A RESOLUTION AUTHORIZING THE ISSUANCE OF AN AMENDATORY SUPPLEMENTAL CHANGE ORDER NO. 1, TO CONTRACT NO. C15-0087 ISSUED TO CHARLES MARANDINO, LLC, MILMAY, NJ, IN THE AMOUNT OF \$62,459.20

Amendatory Supplemental Change Order No. 1
Contract No. C15-0087
Completion of Landis Avenue Resurfacing Project Phase 1
Charles Marandino, LLC, Milmay, NJ

RE: Resurfacing of Landis Avenue Phase 1
Myrtle Avenue to Boulevard
Federal Project No. STP-1030 (108) CON
City Eng. File No. 15-002

CONSTRUCTION FIELD ORDER

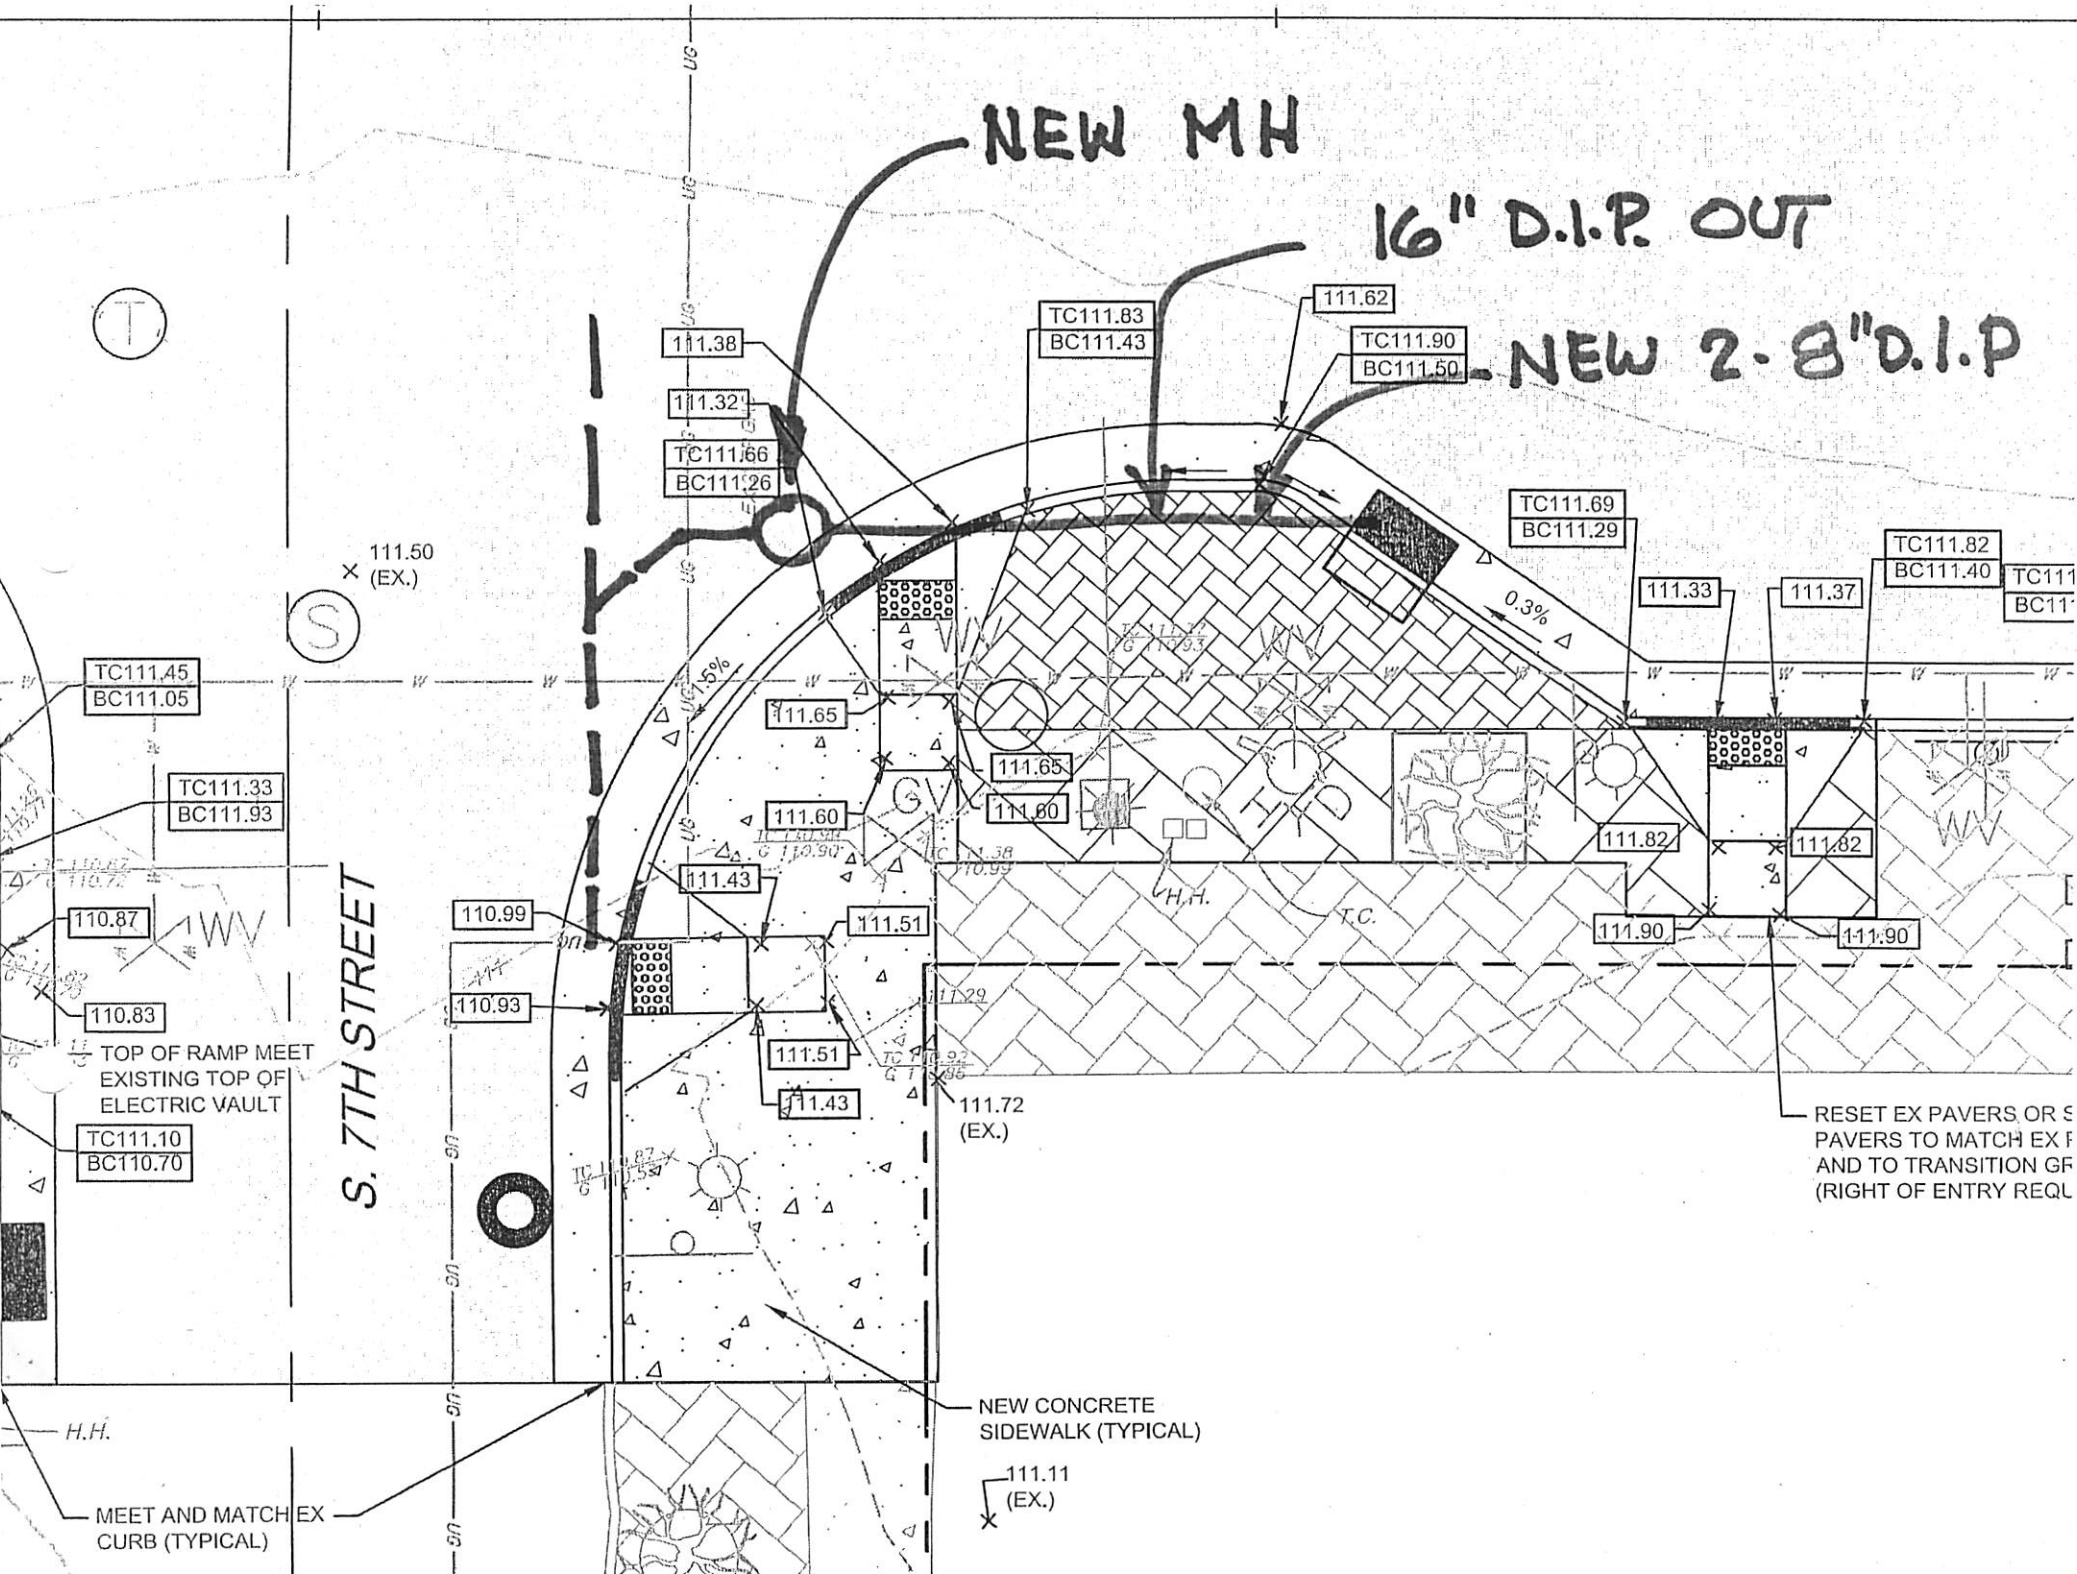
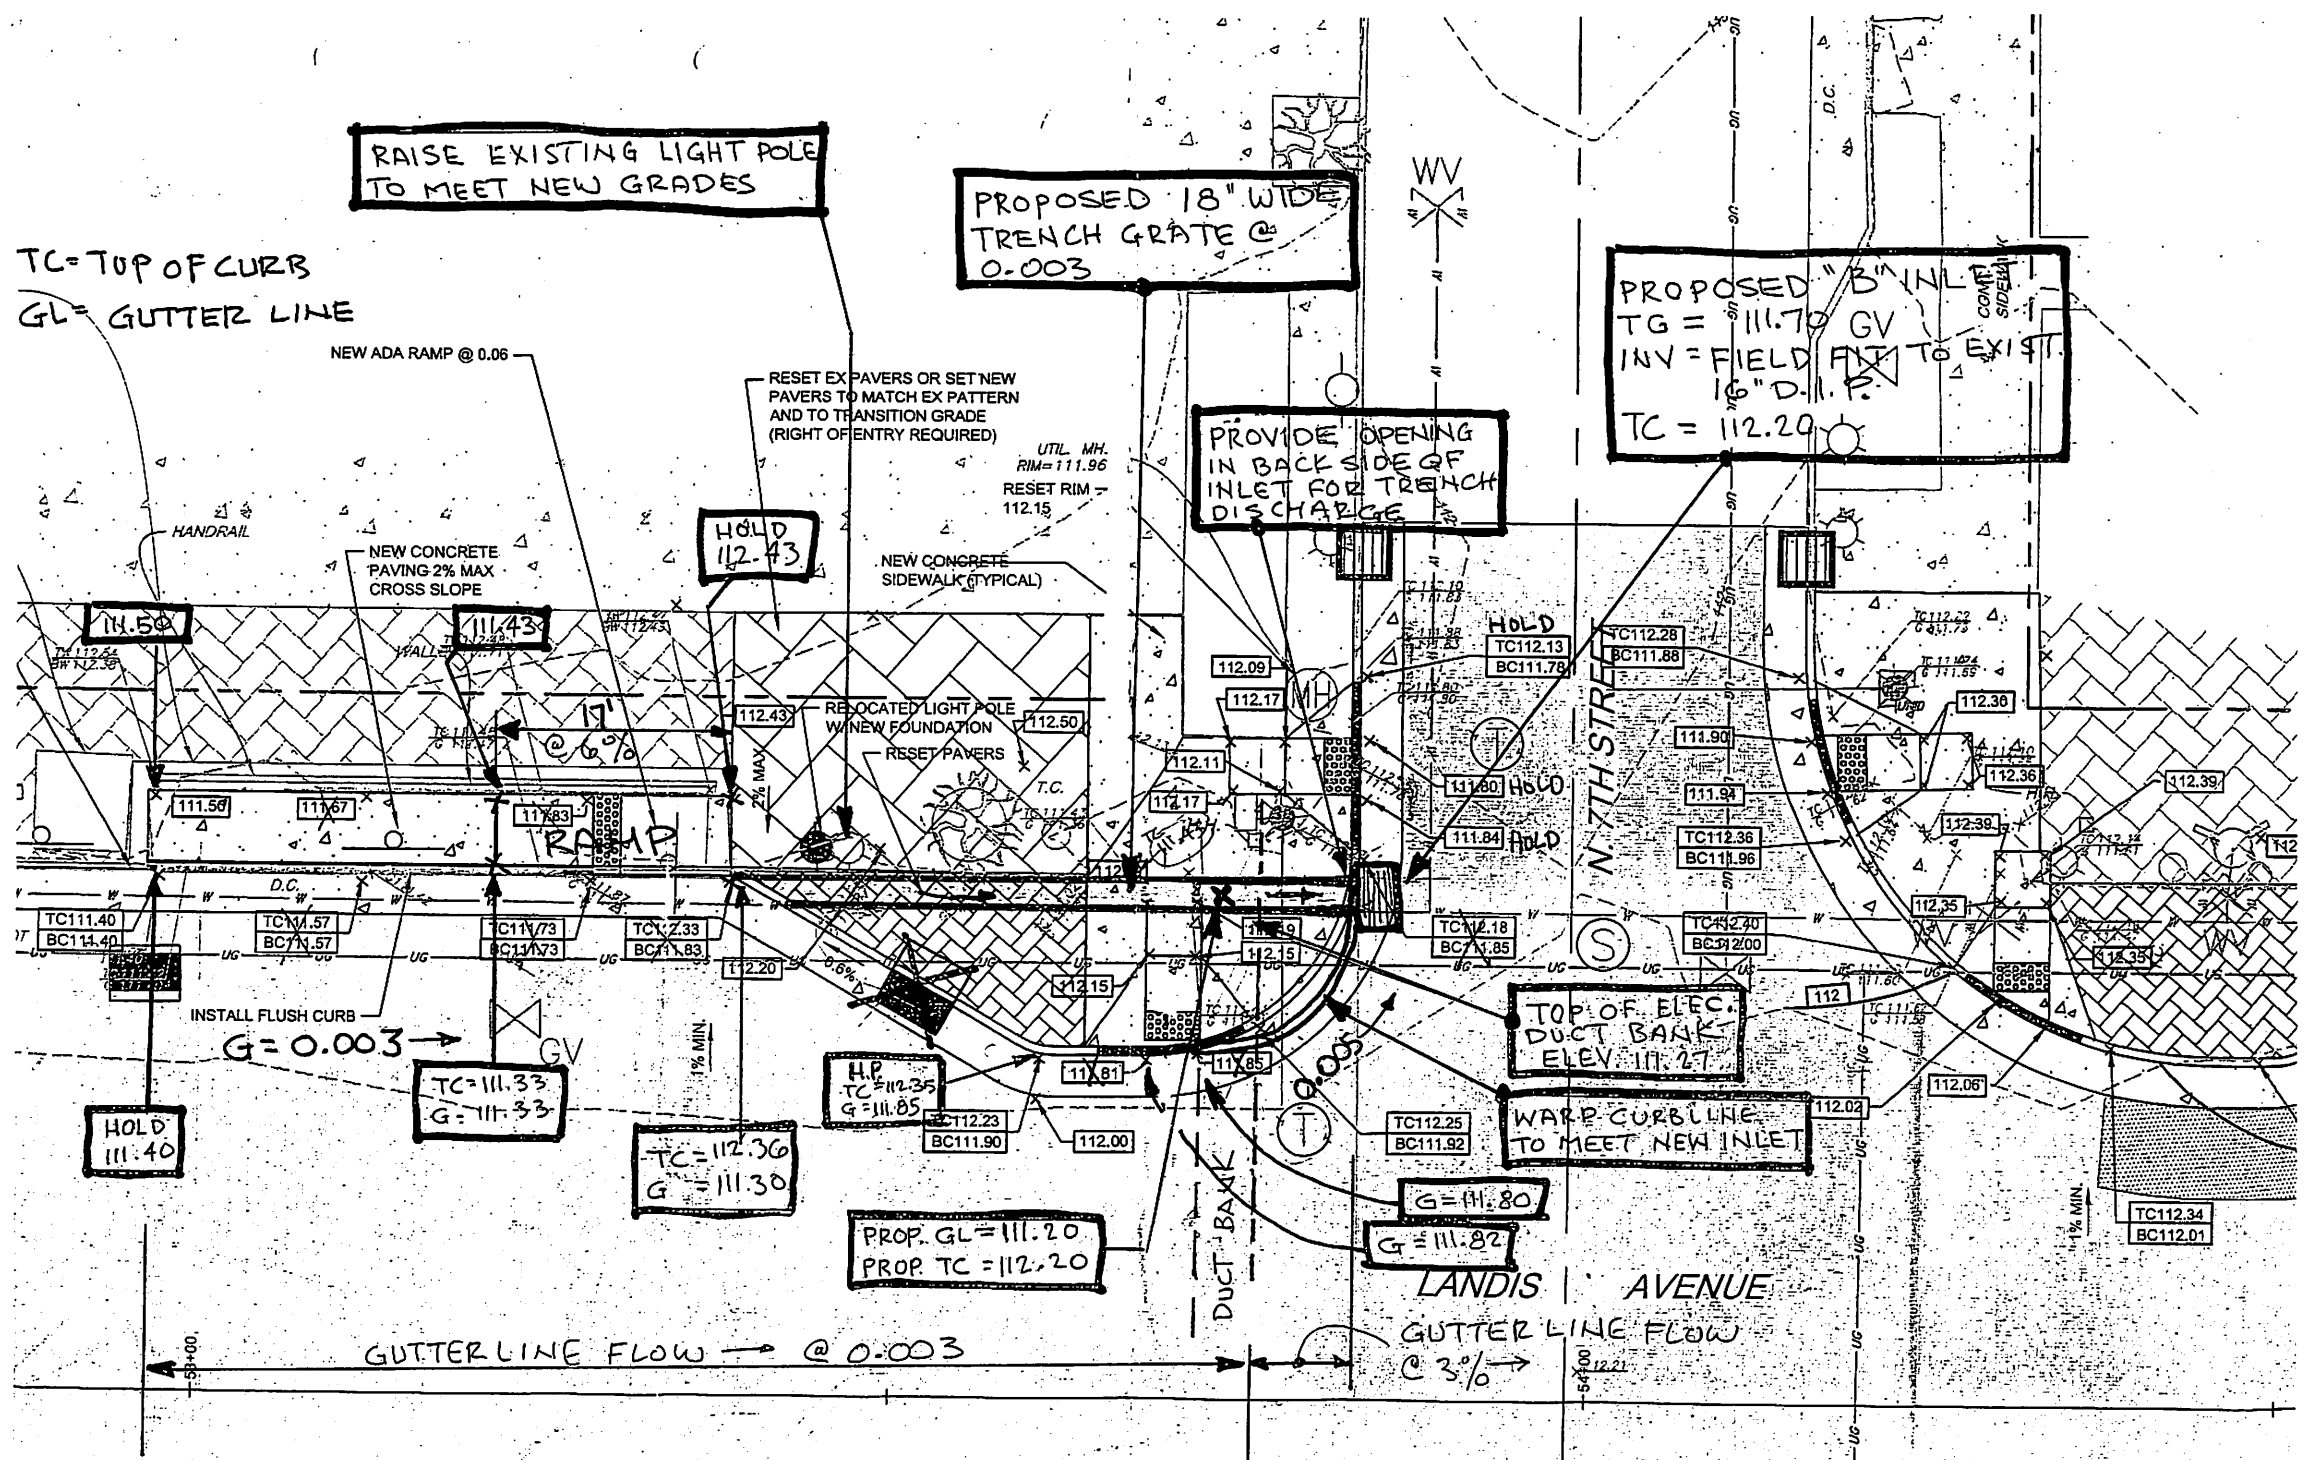
LOCATION OF PROPOSED FIELD ORDER
Intersections of Landis Avenue with 7 th Street and 6 th Street
NATURE OF AND REASON FOR PROPOSED FIELD ORDER
This field order will encompass direction given to the contractor on January 5, as well as dealing with electric utility conflicts which arose on Monday, January 11.
On 1/5, it became apparent that there was a conflict with existing gas main and proposed 16" DIP at the northeast and southeast corners of the intersection with 7 th Street. There were three (3) total conflicts. Two of the conflicts were at the northeast corner. One for the north/south run and one for the east/west run. All resulted in a need to drop the pipe size so that drainage could be installed above the existing gas.
Northeast corner (north/south) – The 16" pipe was swapped out with a single 8" pipe
Northeast corner (east/west) – The 16" pipe was swapped out with a single 8" pipe.
The east/west pipe entered an 8"x8" tee. To the south of the tee, an 8"x16" reducer was installed to connect to 16" (per plan) pipe.

Southeast corner (east/west) – the 16" pipe was swapped out with two – 8" pipes. East of the 16"x16" tee, a new manhole was installed.
On 1/11, the issue of the VMEU electric duct banks made itself evident. One duct bank runs across Landis Avenue along the 7 th Street Right-Of-Way, in line with the sidewalk on the westerly side of the street. The other runs across Landis Avenue along the 6 th Street Right-Of-Way, in line with the sidewalk on the easterly side of the street.
7 th St. Northwest corner – No clearance above the duct bank and going under would not work. Solution is to eliminate the proposed inlets (type A and B near 53+00 and 53+50 LHS) and piping and install a trench grate system above the duct bank, which will dive into a new B inlet to be installed as a doghouse on top of the 16" north/south line. Final design, including grade changes, to be completed by City Engineer. This location will require the installation of four (4) bollards, connected by steel chains to prevent falls. See sketch.

The discussion of how to resolve the duct bank conflicts resulted in DJM deciding that single 8" lines at 7 th Street was not the best solution. Contractor will be installing two additional runs of 8" pipe east/west (northeast corner) and one additional run of 8" pipe north/south (northeast corner). The tee and reducer will be eliminated. An E inlet will be installed.

AFFECTED PAY ITEMS AND QUANTITY CHANGES
B10 – "INLET, TYPE B" → -1 UNIT
B11 – "INLET, TYPE A" → -1 UNIT, +1 UNIT = WASH
B16 – " 16" DIP " → -158 LF
C15 – "RESET MANHOLE CASTING" → -1 UNIT
C16 – "INSTALL MANHOLE" → +1 UNIT
C17 – " 16" DIP " → -80 LF
S1 – " 8" DIP " → +400 LF
S7 – "INLET, TYPE E" → +4 UNITS
S8 – "TRENCH GRATE" → +95 LF
S9 – "BOLLARD SYSTEM" → +1 UNIT
ADDITIONAL NOTES

LANDIS & 7th STREET
SOUTH SIDE

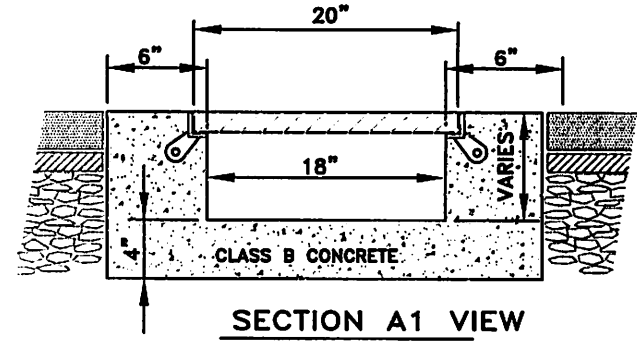
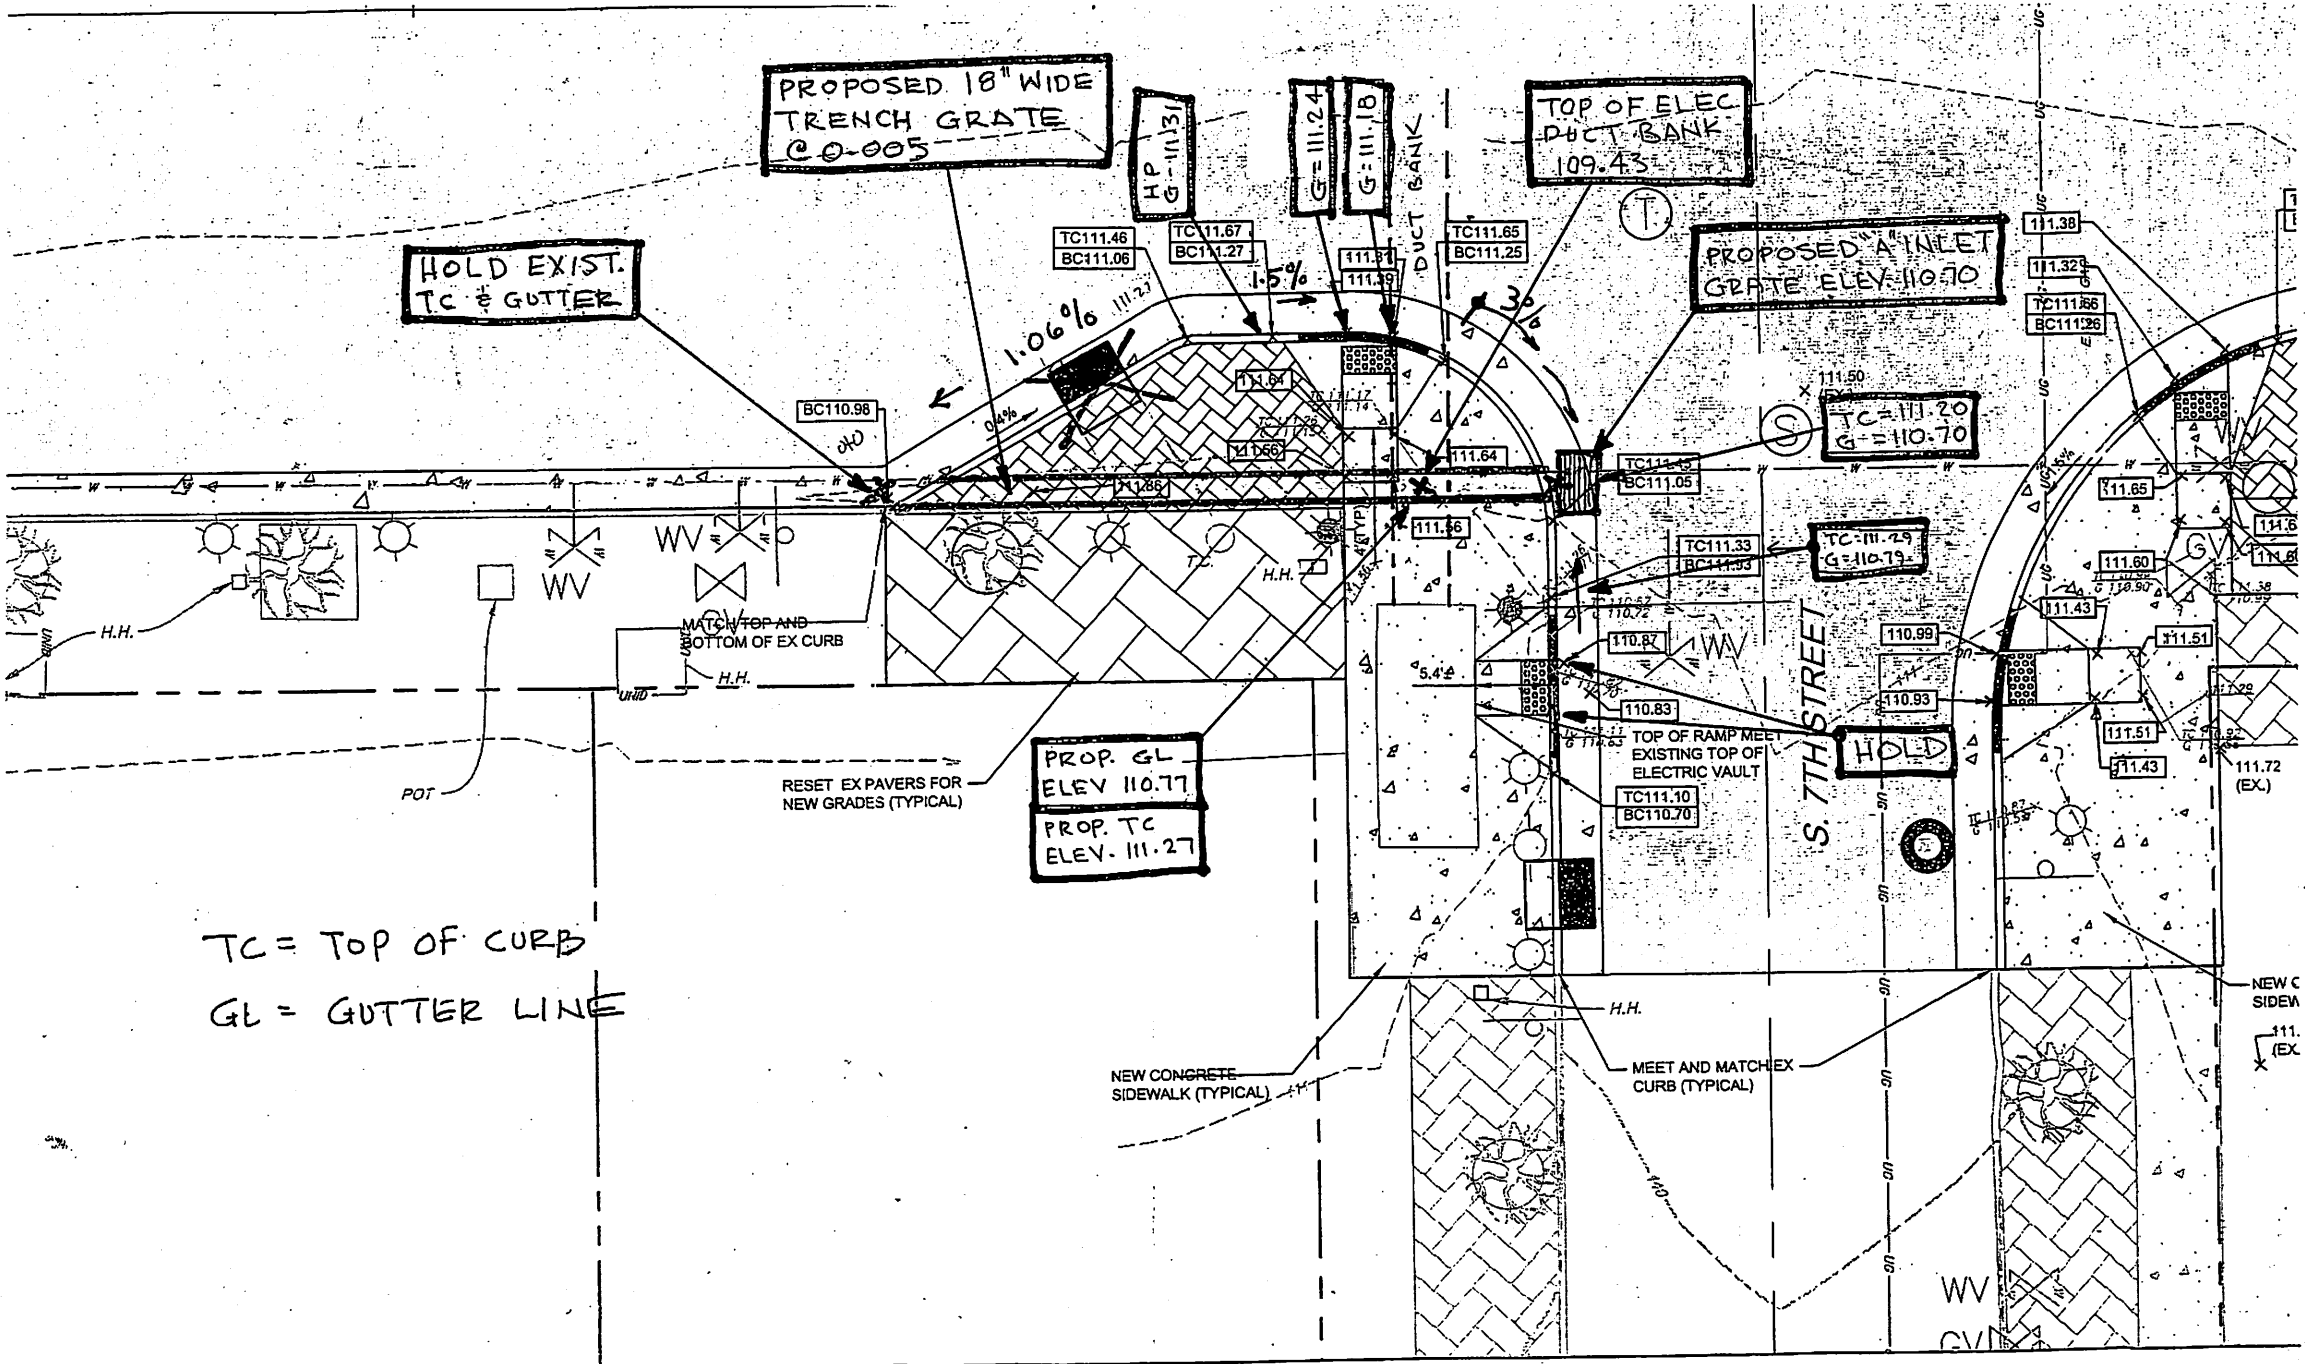
7 th St. Southwest corner – No clearance above the duct bank for 16" pipe. Solution is to eliminate the proposed westerly inlet and piping and install a trench grate system above the duct bank, which will terminate at the curb. A new A inlet will be constructed at this location.
6 th St. Southeast corner – The duct bank appears to follow the grade of the roadway and was not installed level. So, we are not able to follow the path of the proposed 16" pipe. Instead, we are able to install three – 8" pipes above the duct bank in the vicinity of an existing crossing of twin – 6" pipes. This results in a need to install a new A inlet. In addition, it was decided to abandon the concept of wyes and, instead, install inlets for these junction points. Another A inlet will also be installed in this area. See sketch.
6 th St. Northeast corner – There is sufficient room above the duct bank to install three – 8" pipes. The pipes will tie into a new E inlet. See sketch.
